## **EVIDENCE DOCUMENT: EGD/2.2**

### **Proof of Evidence**

Planning Application for the retention of the Wressle 1 Wellsite and access track for the Production of Hydrocarbons, together with an extension of the site by 0.12ha for the installation of additional security facilities; site reconfiguration to facilitate the installation of a new impermeable membrane, French drain and surface water interceptor; construction of a bund, tanker loader plinth and internal roadway system; installation of up to 2 additional groundwater monitoring boreholes and deepening of 3 existing groundwater monitoring boreholes; well operations; installation of production facilities and equipment; installation of gas engine and electrical grid connection; oil and gas production for a temporary period of 15 years; and restoration to arable land.

**Planning Inspectorate Ref:** APP/Y2003/W/19/3221694

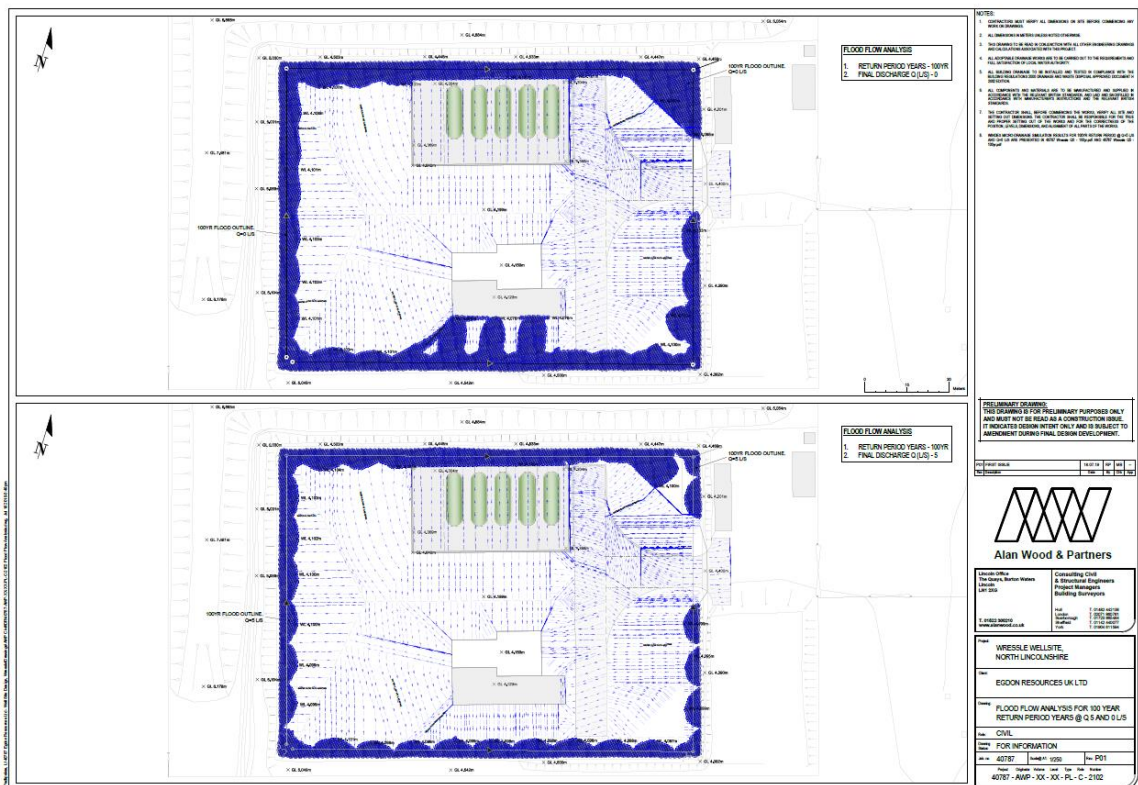
4.27 In Section 2.7 of their Technical Appendix A JBA Consulting has made the following comment:

The testing carried out by Opus on the aggregate in their ground investigation has identified minor contamination to be present but concluded that it is not significant given the end use.

There was no contamination identified in the sub-strata, further testing will be carried out during the CQA process.

With regard to the liner manufacturer we have confirmed with the specialist NAUE that they are satisfied with the use of the 300mm protective stone layer above their HDPE liner.
